CITY OF ALBUQUERQUE

June 13, 2022

RE: 543 Old Coors Dr. SW
Grading and Drainage Plans
Engineer's Stamp Date: 06/11/22
Hydrology File: K11D027

SHEET C-1

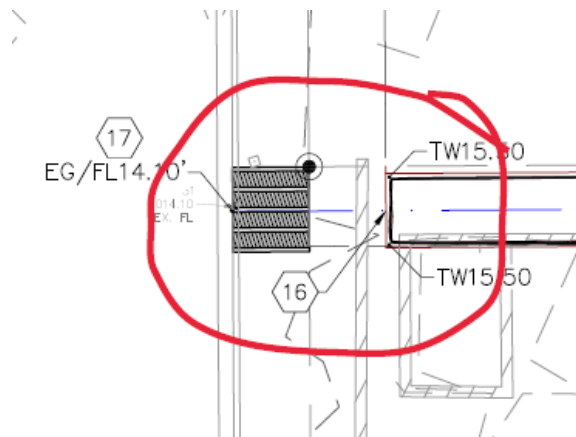
6. Please remove Note #14. This is not allowed within a detention pond. Please use the note in Comment #5 instead.

SHEET C-2

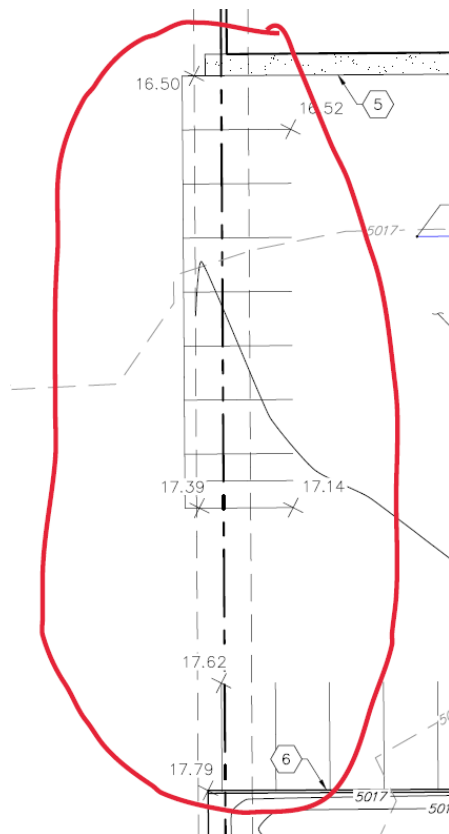
9. Why is this portion of the parking over the property line and into Tract A? Also, where is the edge of the asphalt from the parking to the header wall?

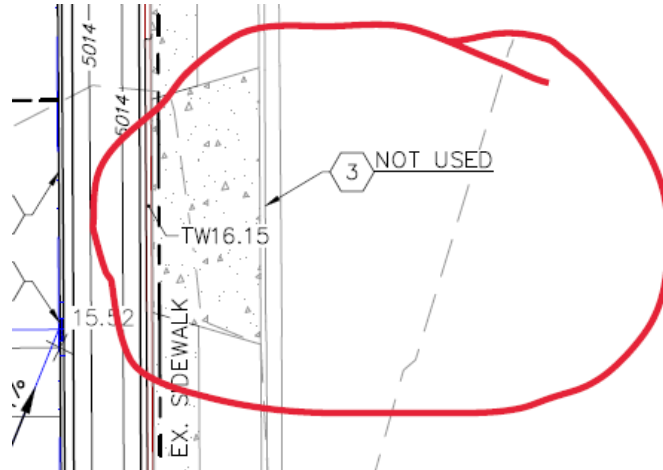
10. The driveway that is not going to be used must be removed and new curb & gutter and sidewalk shown to be installed.

11. How is this detention /stormwater quality pond being discharged? There needs to be some sort of spillway / outfall for it. Please revised.

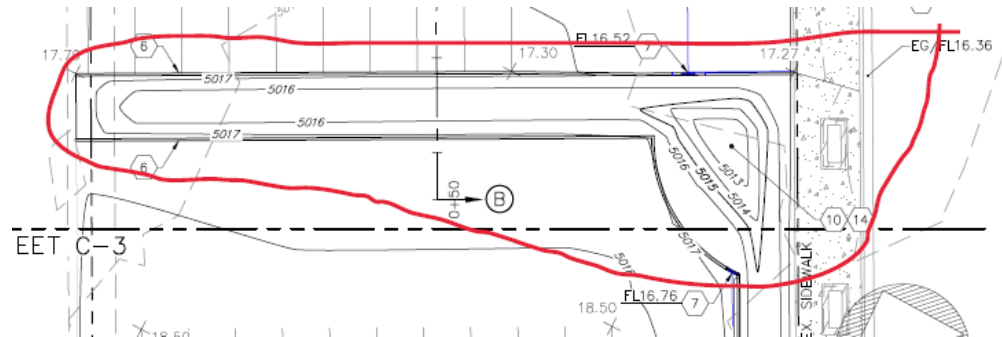
12. How is this detention /stormwater quality pond being discharged? There needs to be some sort of spillway / outfall for it. Please revised.

SHEET C-3

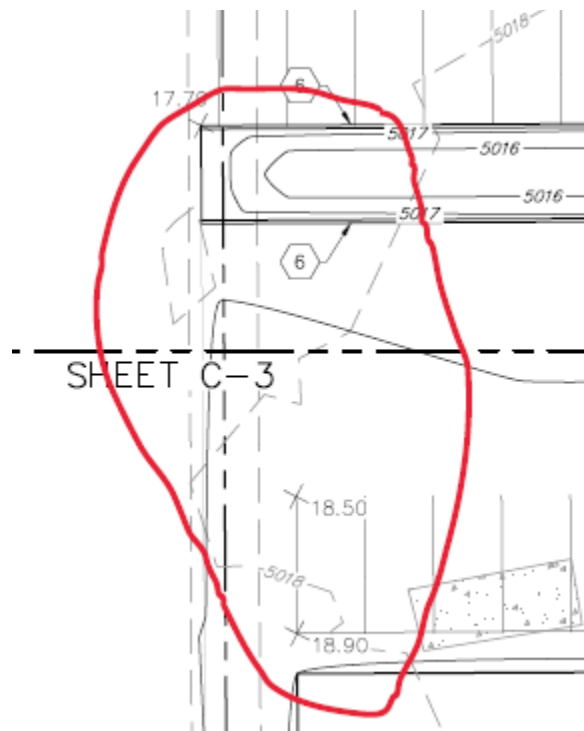
13. Why is this portion of the parking over the property line and into Tract A? Also, where is the edge of the asphalt from the parking to the header wall?

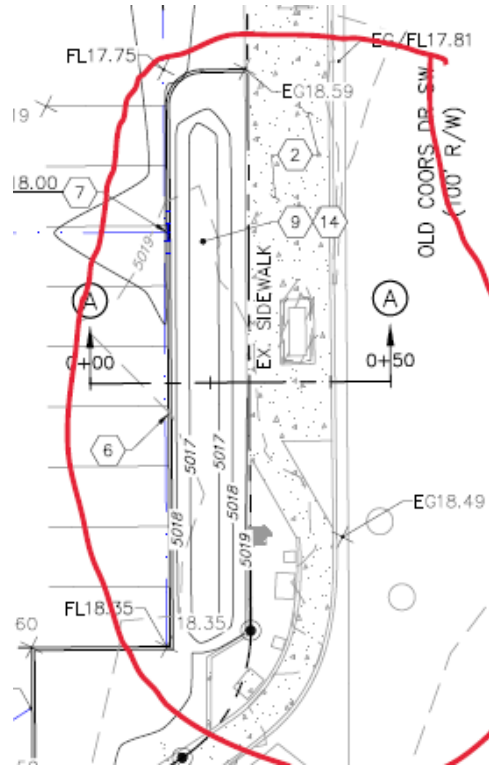
14. How is this detention /stormwater quality pond being discharged? There needs to be some sort of spillway / outfall for it. Please revised.

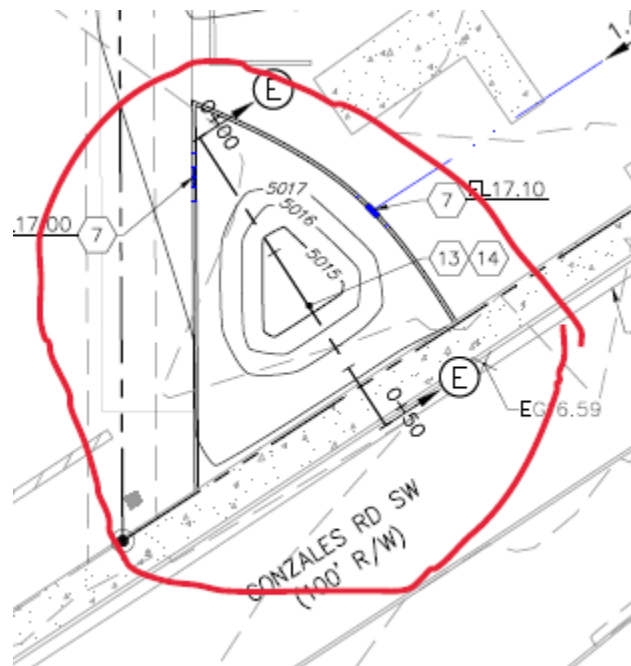
15. How is this detention /stormwater quality pond being discharged? There needs to be some sort of spillway / outfall for it. Please revised.

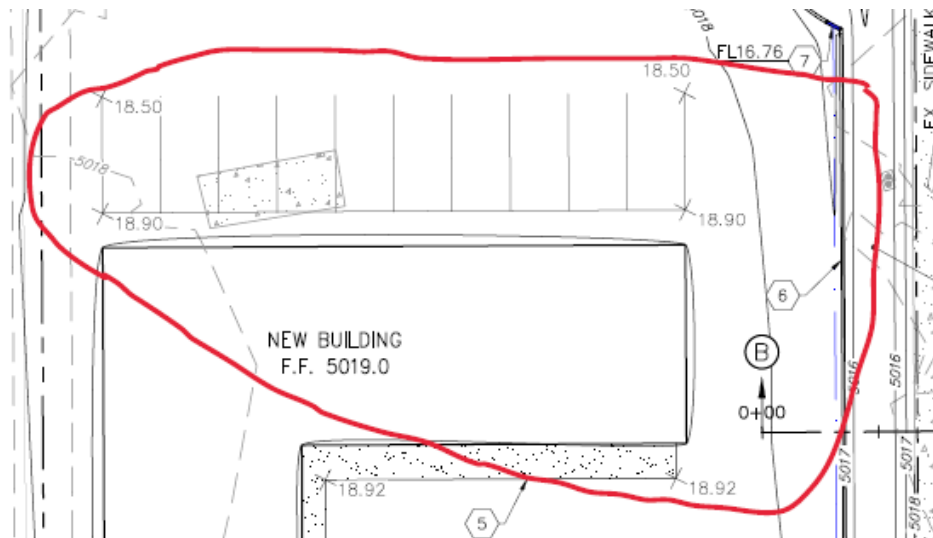
16. Again, I am not quite sure where the edge of asphalt is on this project. Also, what is this piece of concrete for? Is it proposed or existing? All the lines are the same line weights so it is hard to tell what is being proposed and what is existing.

SHEET C-4

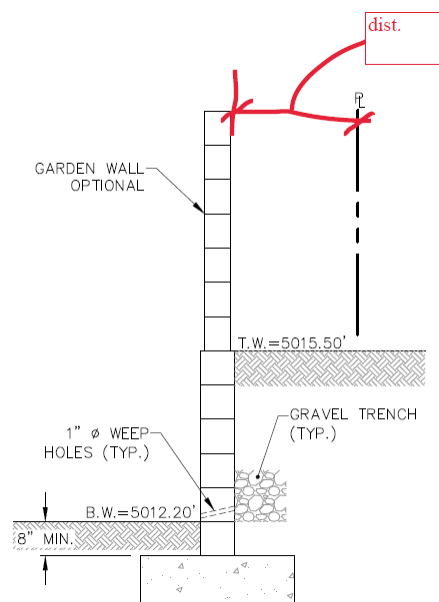
17. Either use your header curb detail or just call out the City Standard Detail. It appears that you have call out the City's detail so the header curb needs to be removed.

18. Please add the distance from the property line to the garden wall.

C-1

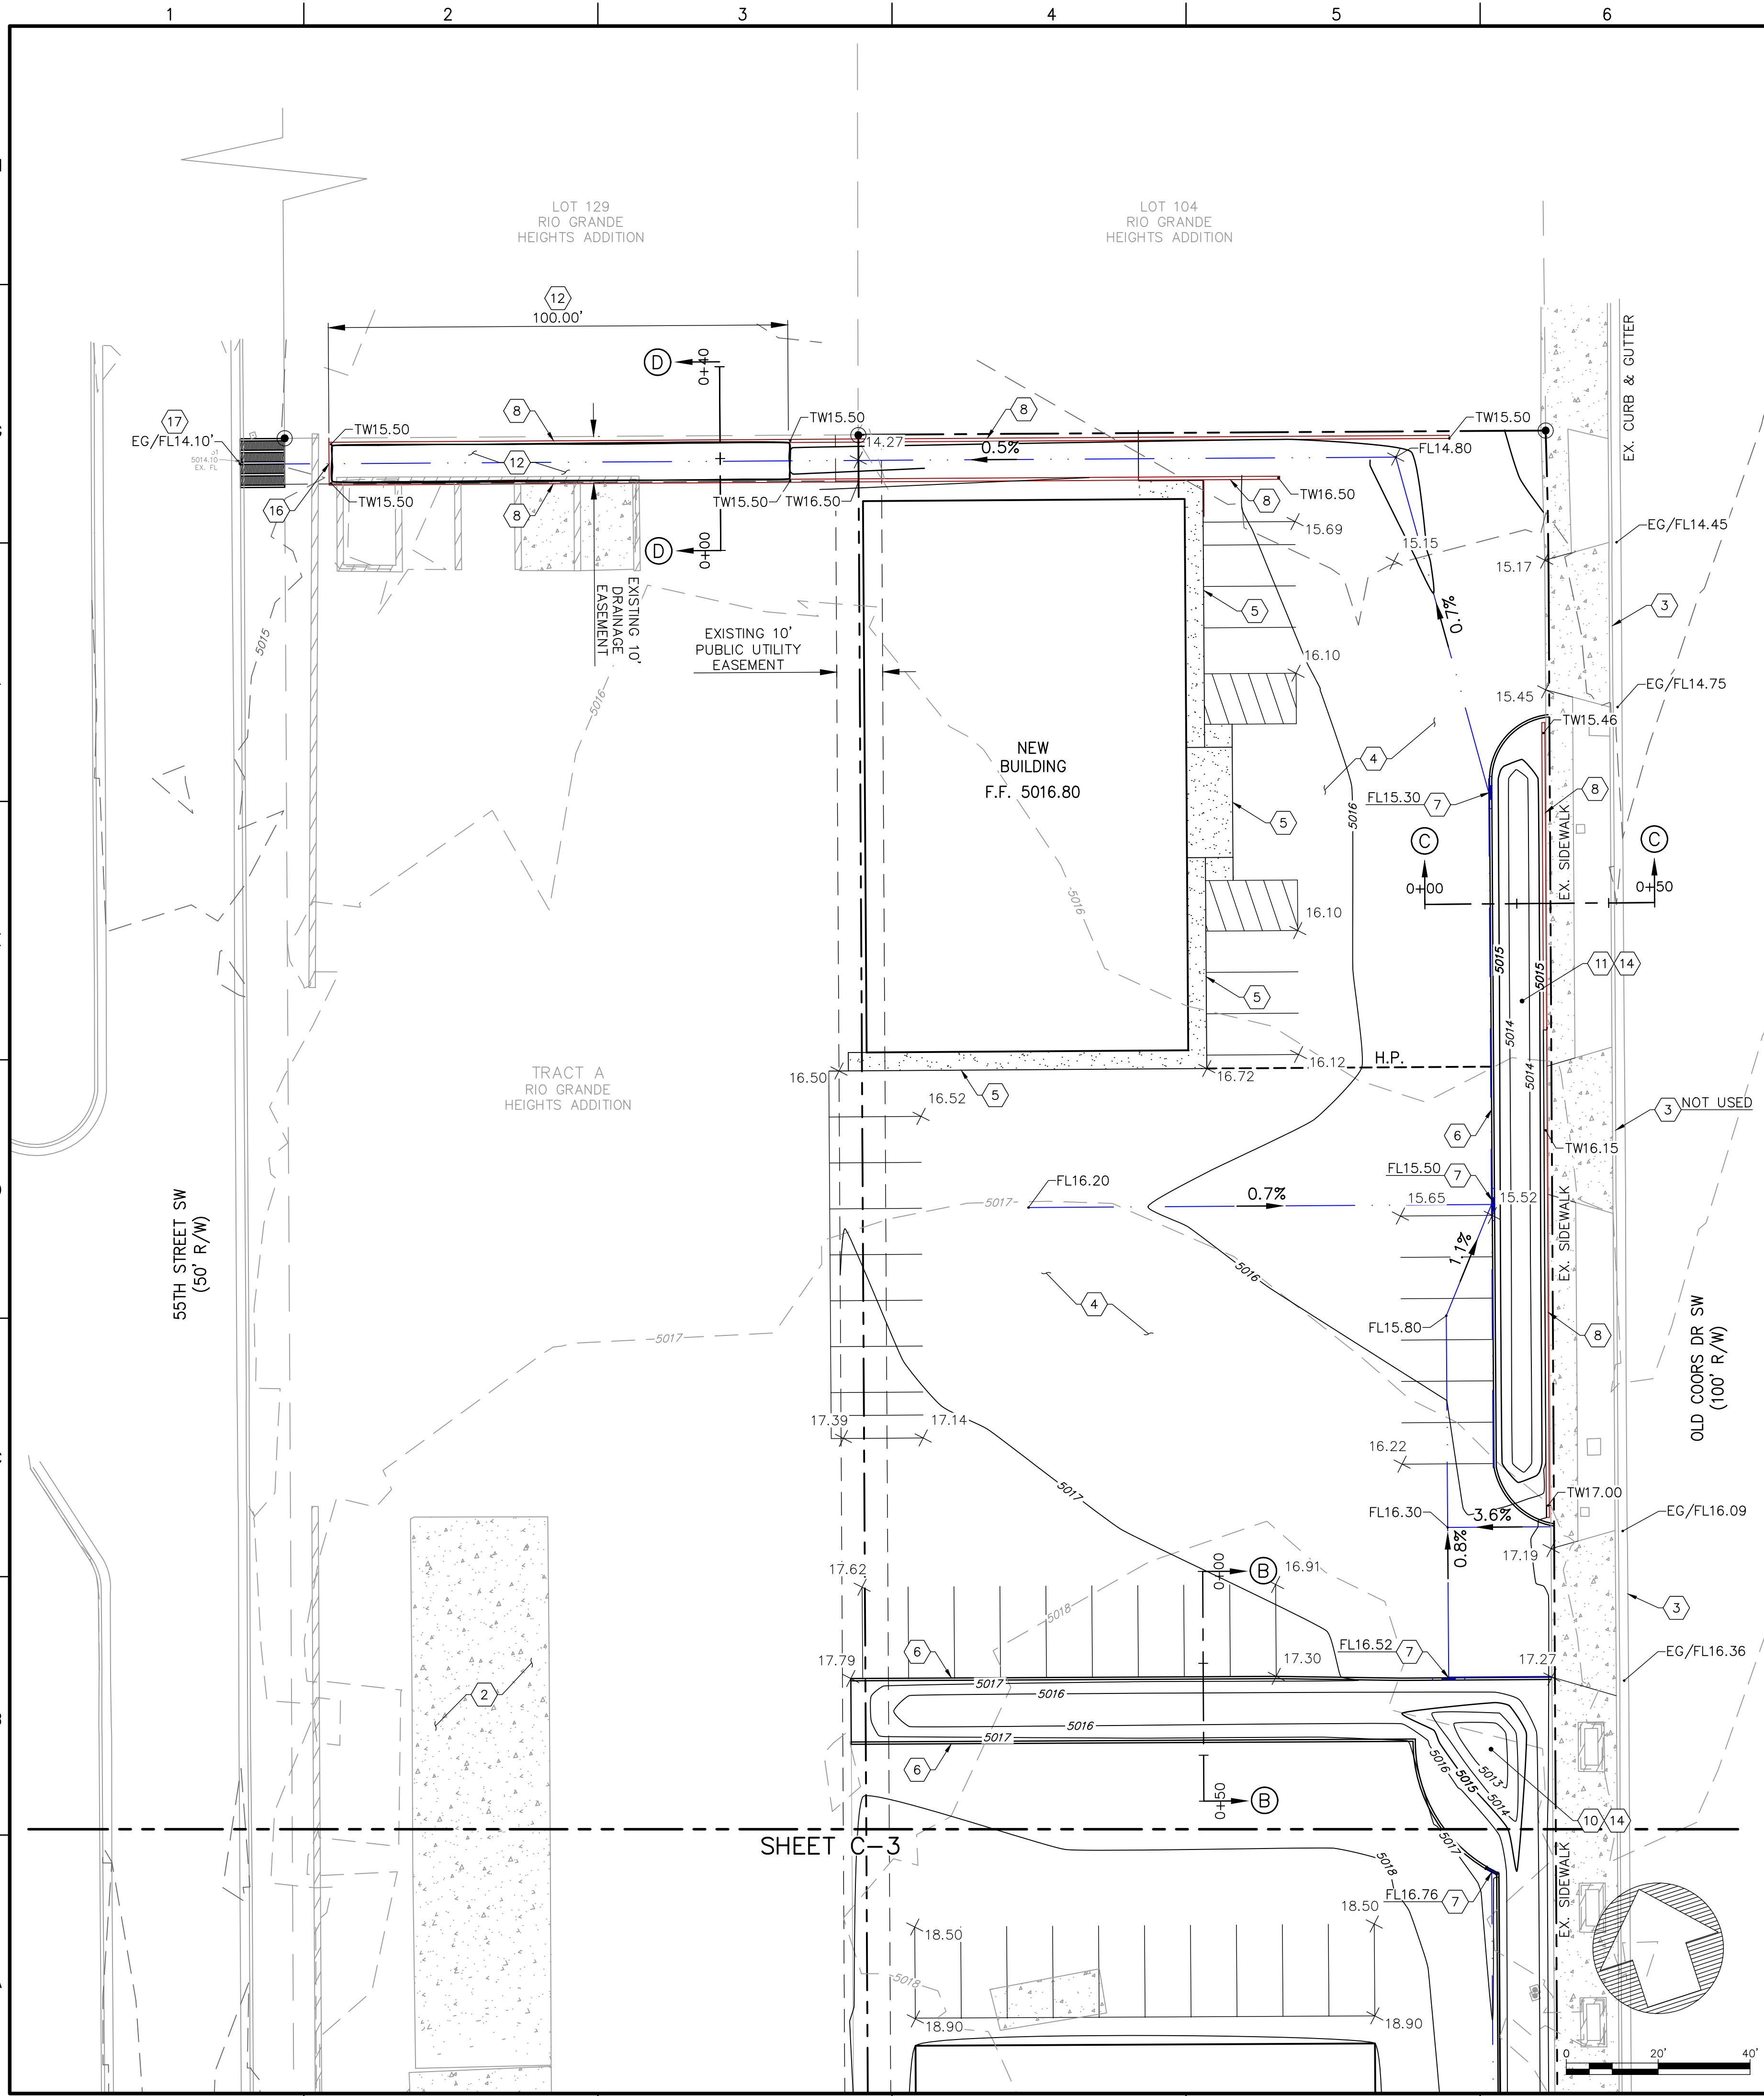
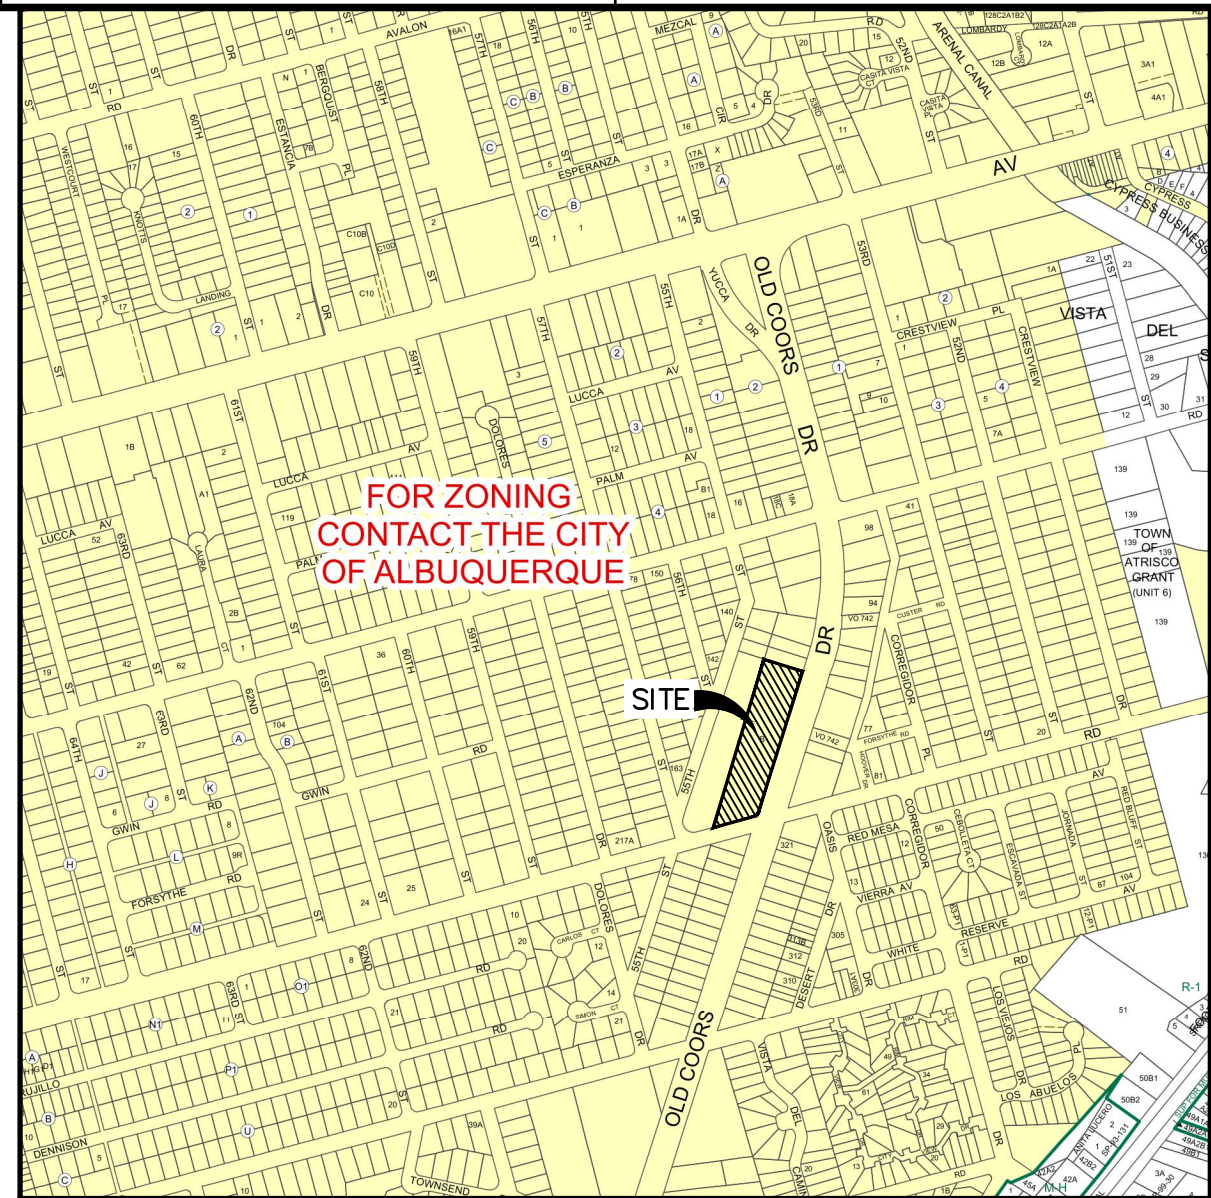
1. Provide written, signed, and notarized letter giving permission from the adjoining property Owner (Tract A, Rio Grande Heights Addition) for work on their property. Even if the property Owner is the same as Tract B, Rio Grande Heights. Does the Owner of Tract A know that there will be a permeant Detention/Water Quality pond on their Tract for only the benefit of Tract B? Is there a reason to encumber Tract A with this pond?

2. Please provide the attached SO-19 notes.
3. All the lines are the same line weights so it is hard to tell what is being proposed and what is existing. Please change this on all sheets.

4. Please note that 3:1 side slope is the maximum allowed within a detention pond without being concrete or vertical walls.
5. Please add the note, "Side slopes need to be stabilized with Native Grass Seed per the City Specification with Aggregate Mulch or equal (Must satisfy the "Final Stabilization criteria" CGP 2.2.14.b.)".
